Subject: Docket No.: 70-3070
Louisiana Energy Services
Claiborne Enrichment Center
Requests For Additional Information
File: MTS-6046-00-2001.01

October 29, 1992
Request for Additional Information

FIGURE 6.4-40

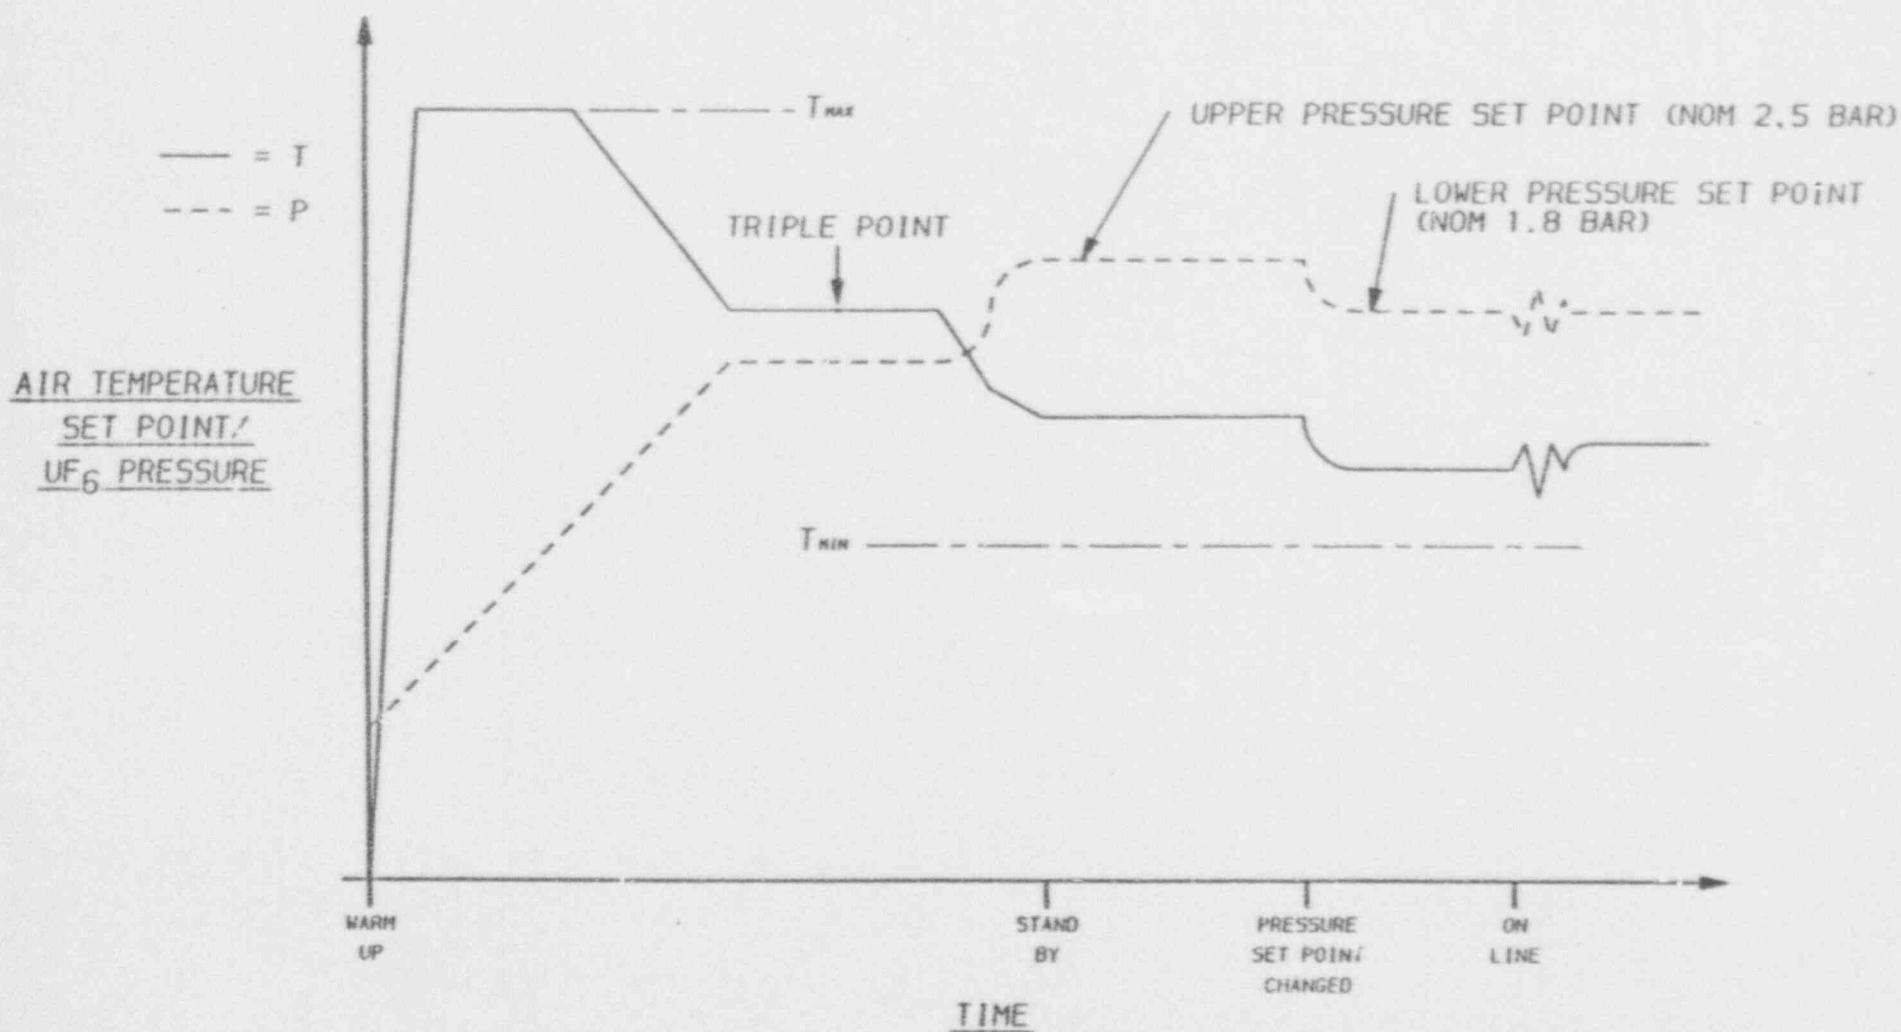
1. The logic diagram of Figure 6.4-40 appears to indicate that the combinations of signals from PE-115 with TE-122 and of PE-118 with TE-127 de-energize the heaters along independent paths. The Mechanical Flow Diagrams for the Feed Autoclave System show the signals from TE-122 and TE-127 entering a common logic unit and the signals from PE-115 and PE-188 entering another common logic unit. Resolve the apparent inconsistency.

2. Figure 6.4-40 appears to indicate that Class II autoclave heater interlocks must be functional to de-energize the autoclave heater contacts. Is this a correct interpretation of this design? If not, clarify the proposed function. If so, provide a rationale for making the function of a Class I system dependent upon the function of a Class II system. Identify the interlocks in question.

5. Provide logic diagrams, analogous to Figure 6.4-40 for all Class I systems (e.g., for blending and sampling autoclaves).

Figure 6.4-40 has been revised to indicate more clearly the signal combinations that satisfy the logic that de-energizes the autoclave heaters and to ensure consistency with the Feed Autoclave Mechanical Flow Diagram (SAR Figure 6.8-1). A copy of revised SAR Figure 6.4-40 is enclosed and will be added to the Safety Analysis Report (SAR). As shown on the revised figure there is no reliance upon Class II autoclave heater interlocks to de-energize the autoclave heater contacts in the event of high autoclave pressure or high autoclave air temperature.

Figure 6.4-40 has been revised to indicate more clearly the signal combinations that satisfy the logic that de-energizes the autoclave heaters. A copy of revised SAR Figure 6.4-40 is enclosed and will be added to the Safety Analysis Report (SAR). As shown on the revised figure there is no reliance upon Class II autoclave heater interlocks to de-energize the autoclave heater contacts in the event of high autoclave pressure or high autoclave air temperature.

SAR Figure 6.4-40 has been relabeled to indicate this logic diagram is the same for Blending and Sampling, as well as Feed Autoclaves.
